**E.2 Proposed Accessible Parking Requirements and Design Criteria**

## **G.2 Proposed Accessible Parking Requirements and Design Criteria**

Committee received a report dated January 28, 2021 from the Director of Engineering and Public Works regarding recommendations to establish new regulations for the supply and design of off-street accessible parking for new developments as well as new design criteria for City supplied accessible parking stalls.

Exhibit 3 - More effective Accessible Parking Signage, with enforcement messaging

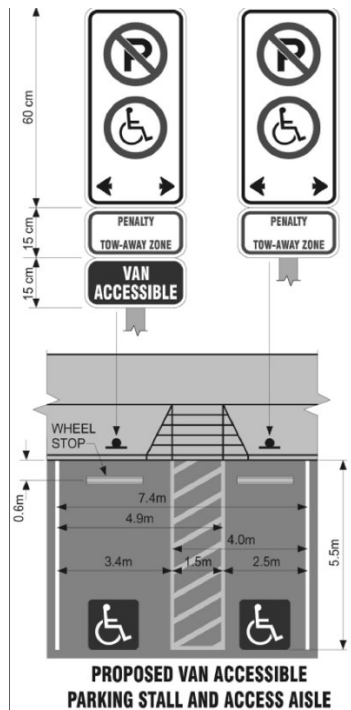
In most underground parking, stalls will be against a wall and curbs will not be visible. Other wall markings may be advisable. Two circumstances – pole and wall signage should be covered. How are they to be mounted to concrete walls, or is other forms of signage or markings allowed in this circumstance? How about a blue stripe at a certain level? Can signage be affixed with glues that do not allow them to be pried off any more easily than removed from a post?

This would be improved by enforcement messages and, particular to private parking, the phone number of the owner to whom infractions should be reported. Neither police nor Bylaw officers will enforce infractions on private parking unless it is the owner who will respond. This is a large gap in the regulatory regime that essentially makes AP restrictions on private property a fiction. The need to contact someone who can request enforcement is essential to the success of AP in the private sector. See Exhibit 3 below. It indicates penalties, but should have phone numbers too.

Why is blue background being recommended for the pavement marking? Although it is familiar, it seems to be more common to have white directly on the pavement. What are the perceived benefits of the blue background, and do they outweigh the additional installation cost and maintenance? Might a similar effect be gained by putting a blue wide bar at the entrance to a stall? That would be more easily spotted by PWD scouting for spots and parking enforcement.
